UNITED STATES PATENT AND TRADEMARK OFFICE

APPLICATION NO.	FILING DATE	FIRST NAMED INVENTOR	ATTORNEY DOCKET NO.	CONFIRMATION NO.
10/709,566	05/13/2004	Nadine Marie Lukes-Dyer		3565
41660	7590	03/28/2005		EXAMINER
NADINE M. LUKES-DYER 2717 VIA PORTOLA FULLERTON, CA 92835			LAU, HOI CHING	
			ART UNIT	PAPER NUMBER
			2636

Office Action Summary	Application No.	Applicant(s)
	10/709,566	LUKES-DYER, NADINE MARIE
	Examiner Hoi C. Lau	Art Unit 2636

Baby in Car Alert
Nadine Marie Lukes-Dyer
Customer ID# 000041660
714-457-9496

Figure 2 - Items in View

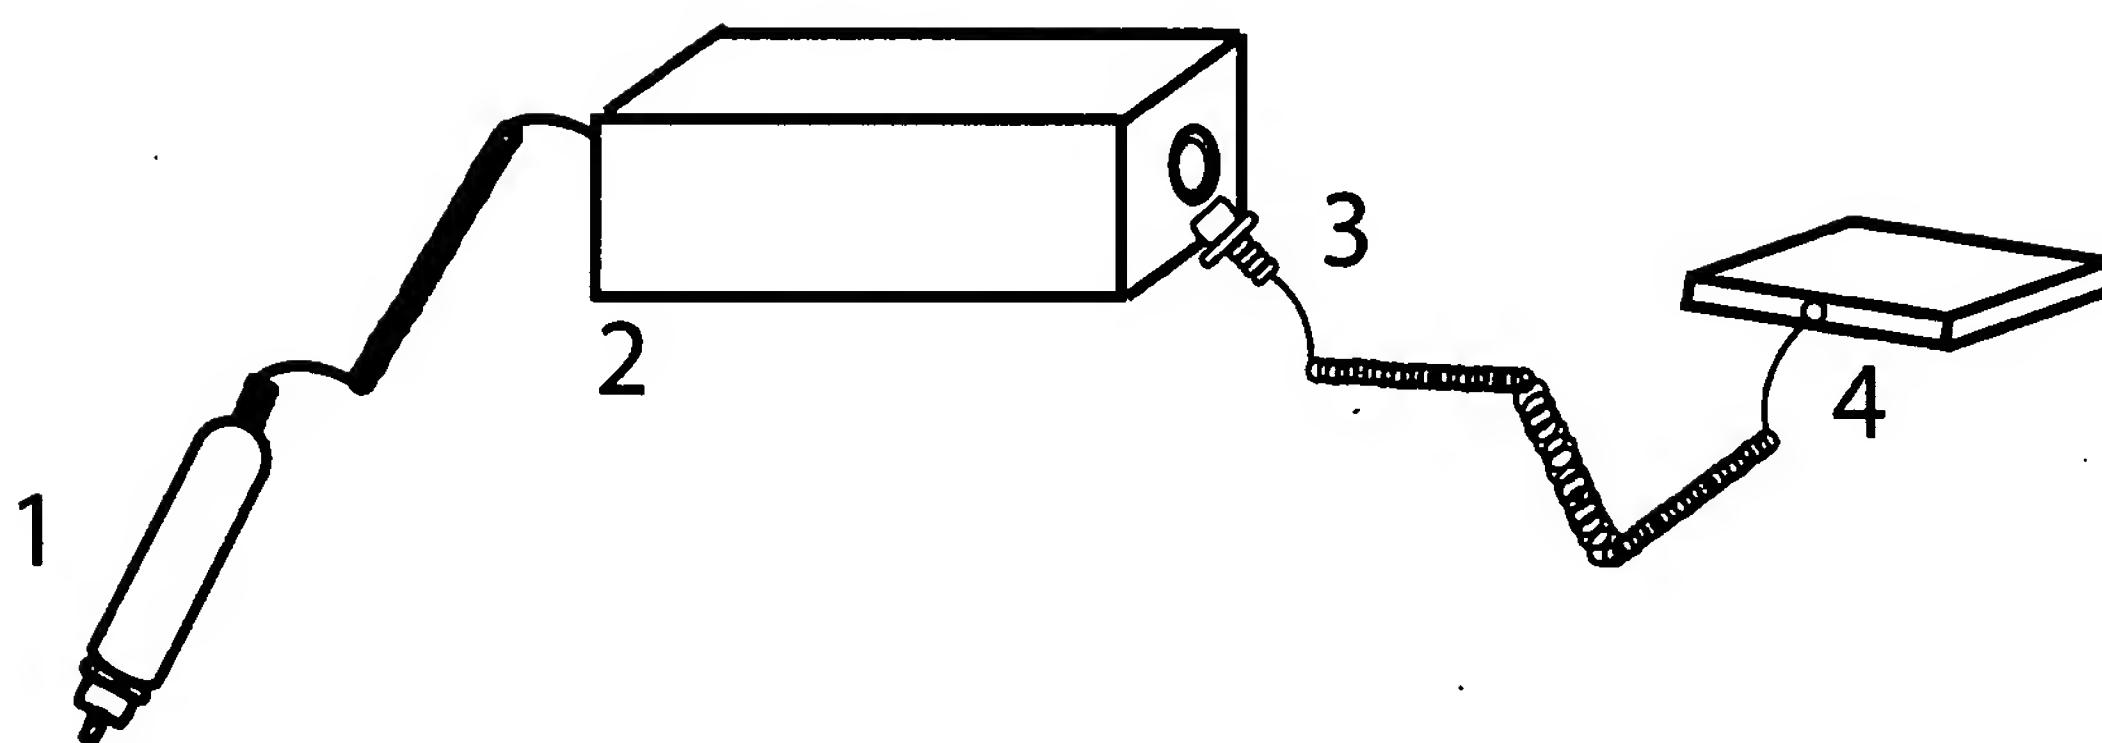
2. The drawings are objected to as failing to comply with 37 CFR 1.84(p)(5) because they include the following reference character(s) not mentioned in the description: Figure 2 item 1 and Figure 3 item 1 (Cigarette Lighter Adapter). Corrected drawing sheets in compliance with 37 CFR 1.121(d), or amendment to the specification to add the reference character(s) in the description in compliance with 37 CFR 1.121(b) are required in reply to the Office action to avoid abandonment of the application. Any amended replacement drawing sheet should include all of the figures appearing on the immediate prior version of the sheet, even if only one figure is being amended. Each drawing sheet submitted after the filing date of an application must be labeled in the top margin as either "Replacement Sheet" or "New Sheet" pursuant to 37 CFR 1.121(d). If the changes are not accepted by the examiner, the applicant will be notified and informed of any required corrective action in the next Office action. The objection to the drawings will not be held in abeyance.
